GENERAL APPLICATION

Location Address: 2202-2204 Van Buren Street

SUBJECT: Preliminary Site Plan review for a 42 Unit residential development.

PROPOSED 42-UNITS MULTI FAMILY DEVELOPMENT FOR::
VAN BUREN FLATS
2202-2204 VAN BURREN STREET, 1-4
HOLLYWOOD, FLORIDA 33020

7 PROPOSED SITE PLAN

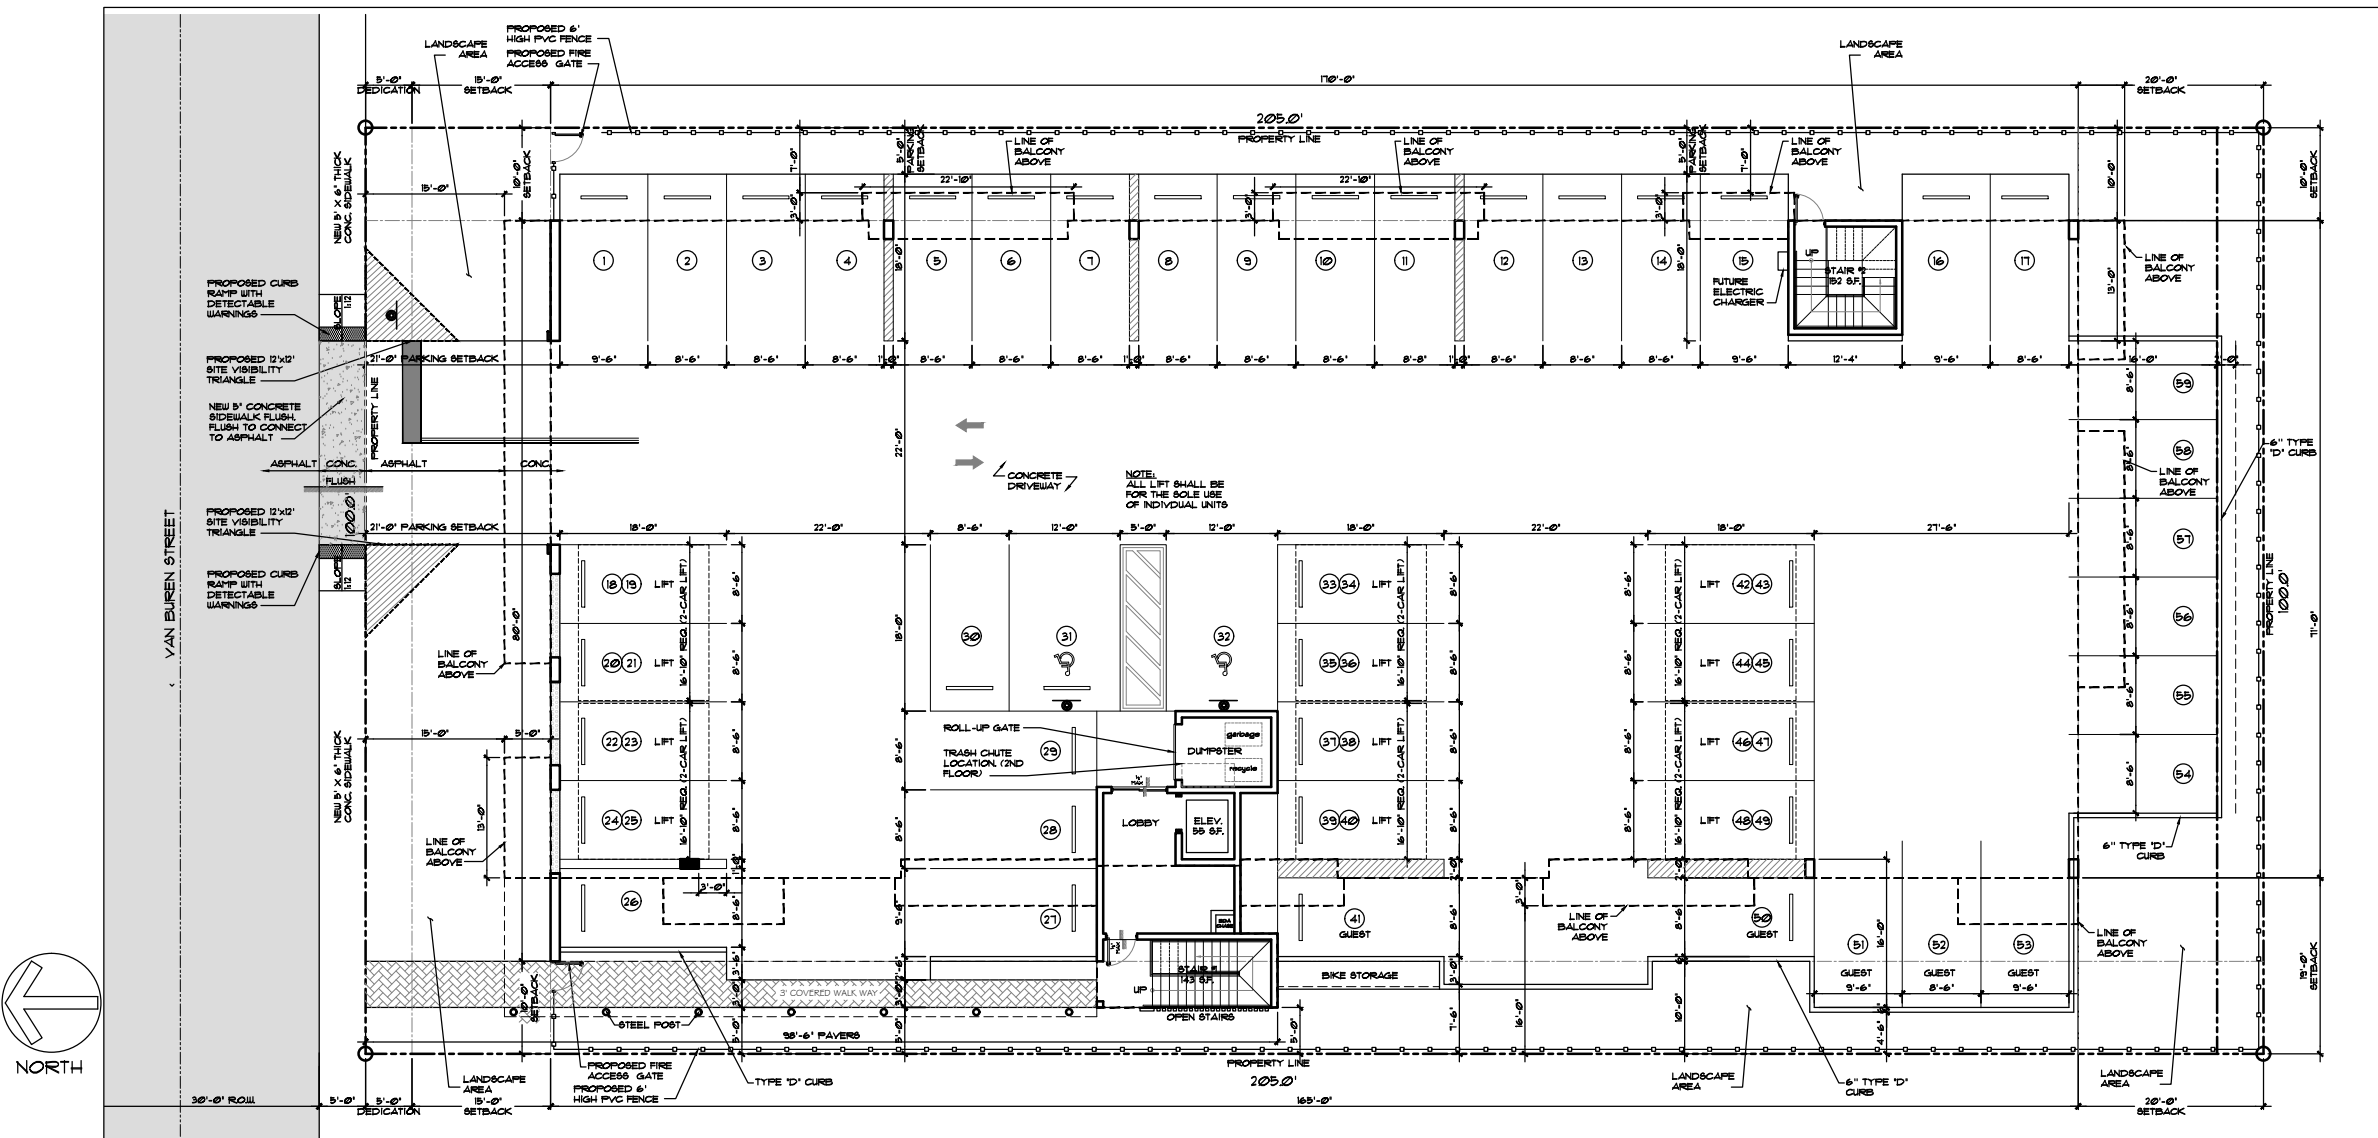
1. Site Plan:
 - a. Use a heavier line weight and label the building location. As submitted, it is difficult to determine where the footprint of the building is shown on the site plan.

- g. Note 1 references two entrances. Is this a typo?
Response: Revised Accordingly, refer to SP-1.
 - h. Note 2 references Monroe St. Include correct street name.

- a. The incorrect zoning district is listed. The property is zoned DH-2. Revise the data to reference the correct zoning district and regulations (FAR, setback, height).

- 6. The stairs on the east side of the building do not connect to any internal walkway. Note, concrete slabs/landings shall provide a minimum 3' setback from all property lines, unless providing access to right- of-way.

8. Based on the elevations, renderings and site plan, parking space 26 appears to be adjacent to a wall on both sides and is required to be widened to 10'-6".

9. Add a note to the site plan that the parking lift system shall not be for the use of guests.

Response: Revised Accordingly, refer to SP-1.
 - b. The front setback dimensions of the site plan and site data shall be revised match.
Response: Revised Accordingly, refer to SP-1.

Response: Revised Accordingly, refer to SP-1.

Response: Revised Accordingly, refer to SP-1.

Response: Can we discuss this issue with Andria W. as well. The code references encroachment of 50% into front setback. Our Stair which is an entry feature on the side is placed there due to the lots depth and will act as a central location. I can redesign to meet setback but it ruins the pedestrian walkway and hierarchical feature.

Response: Refer to revised Site Plan and Elevation showing column and not a wall

Response: Revised Accordingly, refer to SP-1.

6 WALKWAY DETAIL
SCALE: 1/8" = 1'-0"

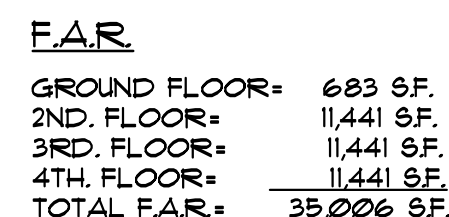
Response: Revised Accordingly, refer to SP-1.
 - f. Specify the purpose of Detail 6 on the plan. It is unclear what this detail is referencing.
Response: Removed not applicable

1 PROPOSED NORTH ELEVATION
SCALE: 1/8"=1'-0"

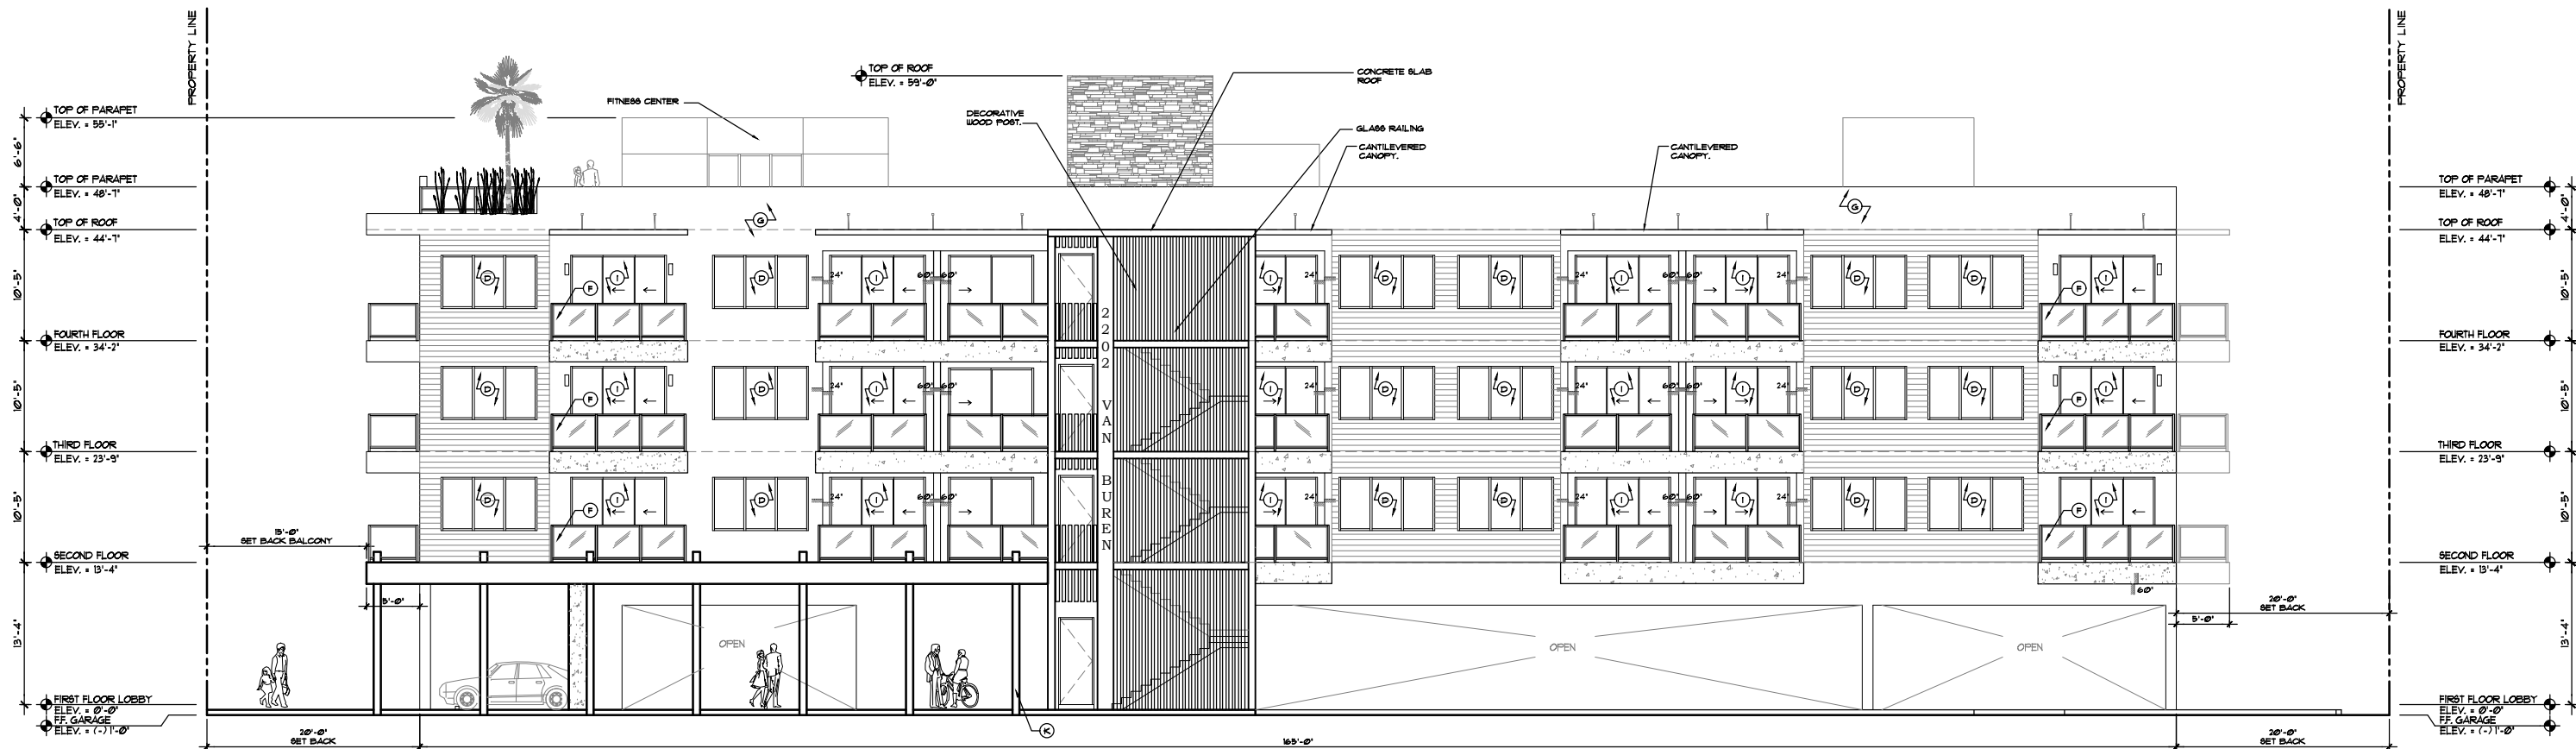
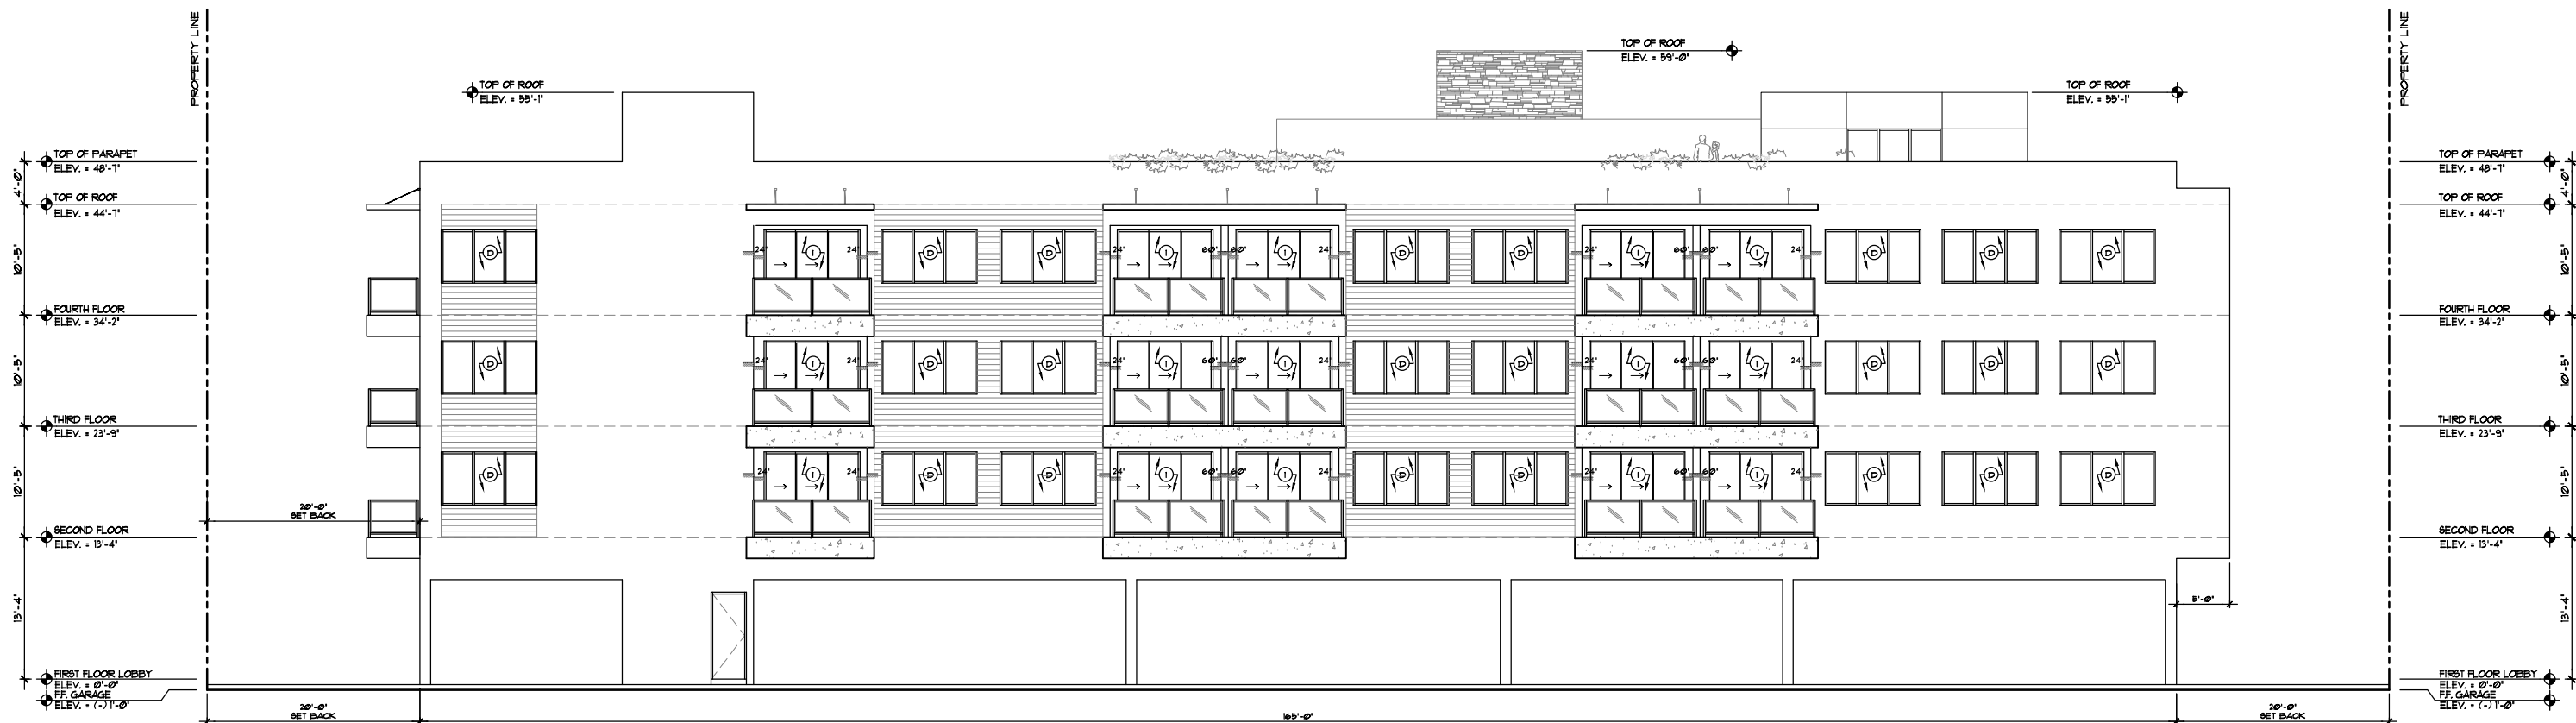
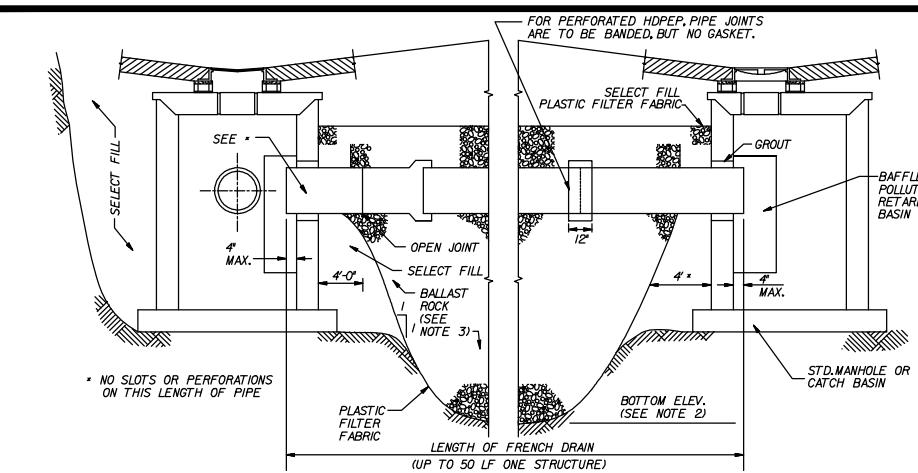
5. The floor plans and roof plan indicate the stairs extend all the way to the roof level, but the elevations do not reflect same. Revise all plans for consistency and ensure design meets setback and height limitation requirements.

7. It is unclear if the east elevation is open on the first floor. The site plans and floor plans suggest it is, however, the elevations are not labelled. ***Response: revised Accordingly***

10. Remove landscaping and furnishings from the elevation sheets.

Response: revised Accordingly

| SHEET | C-1.1 |

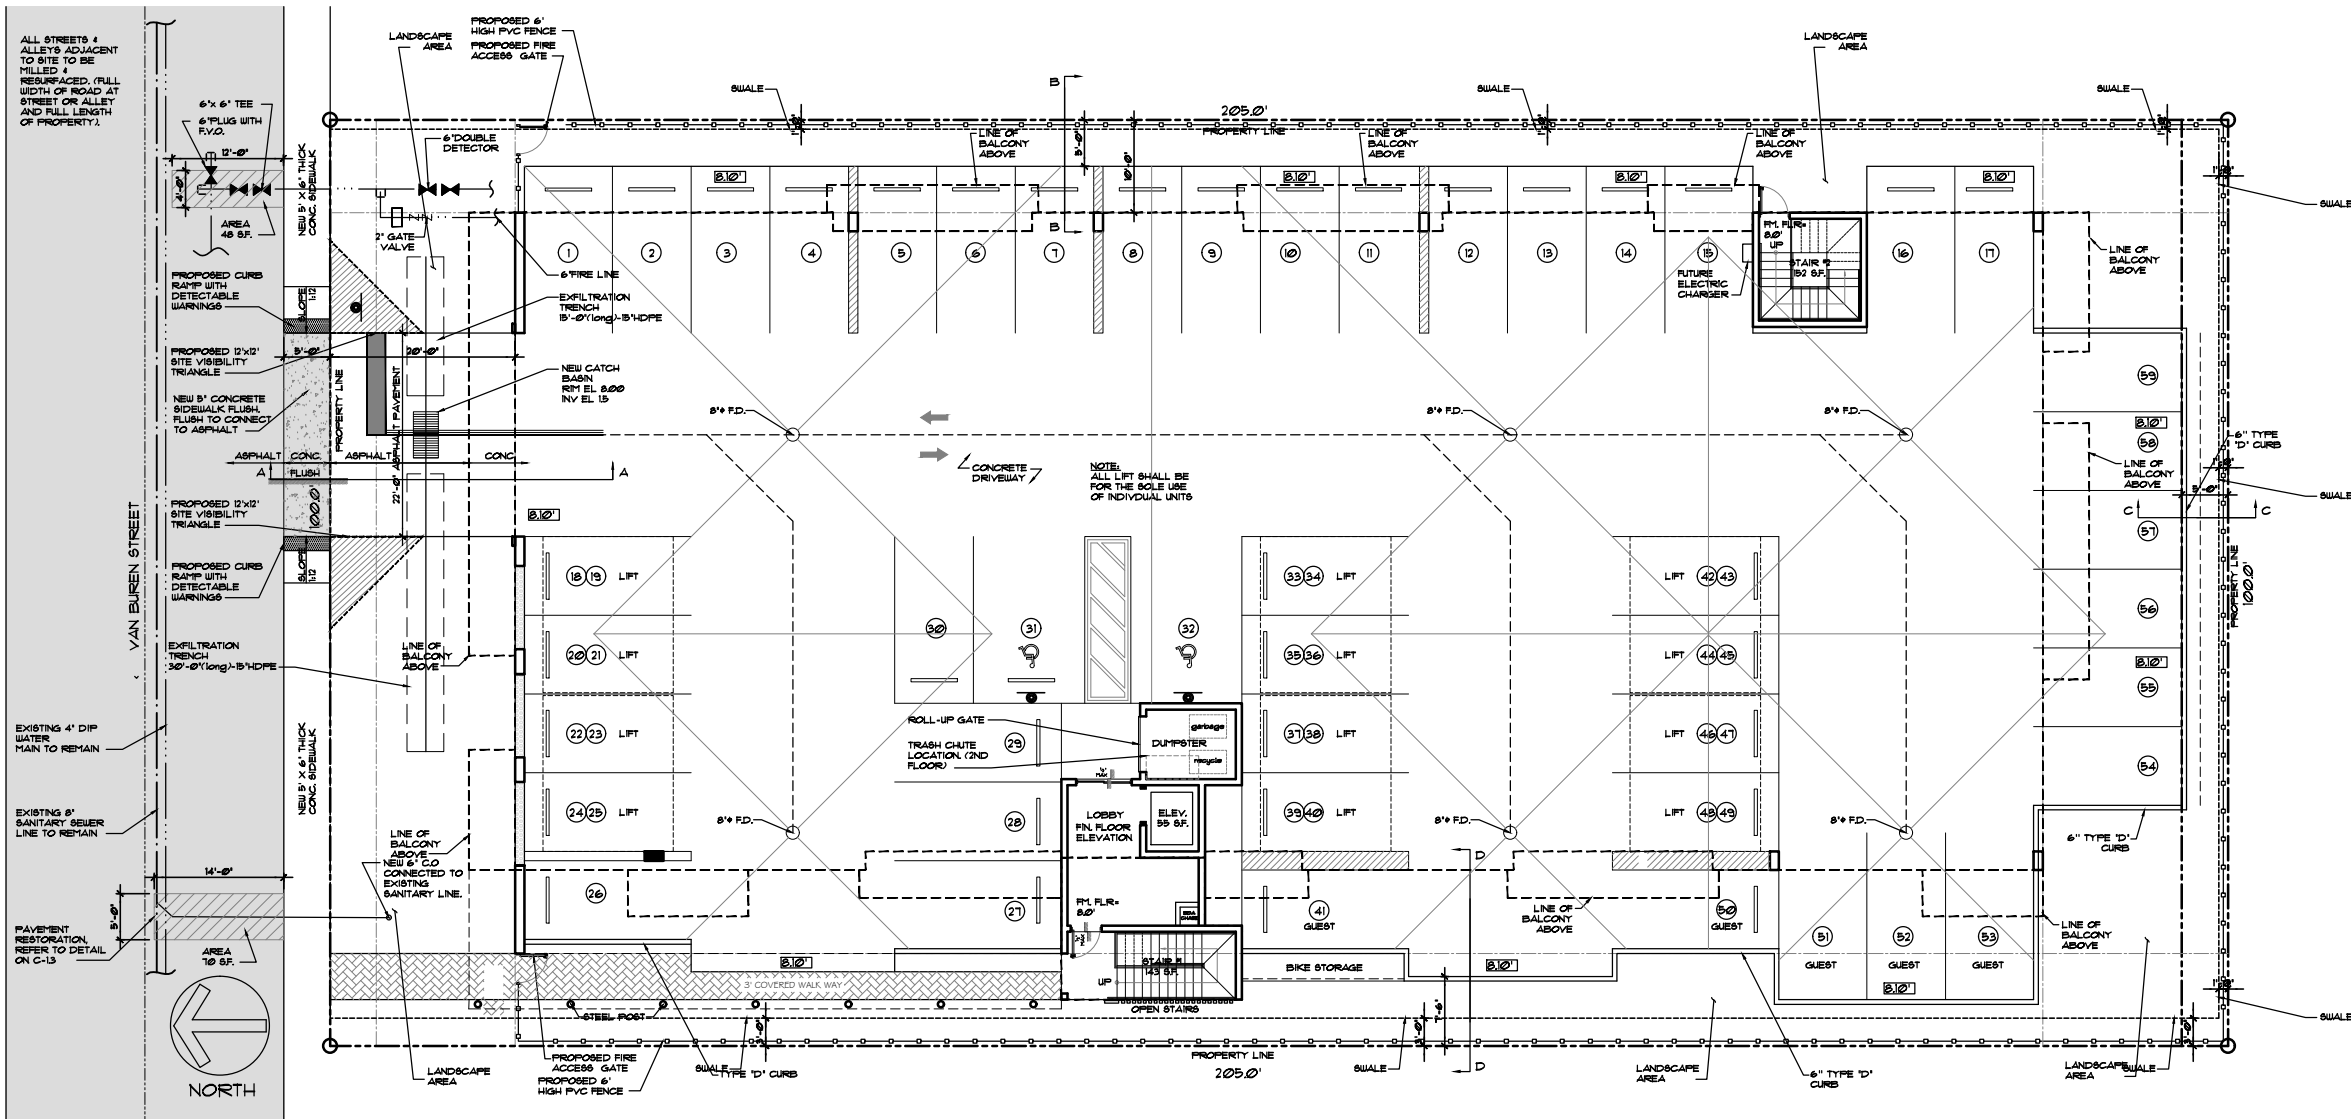
8. Show dimensions of setbacks on plan view of Sheet C-1.1 to match dimensions provided on sections.

11. Show swale areas on plan view of Sheet C-1.1.

Response: revised Accordingly

Response: revised Accordingly
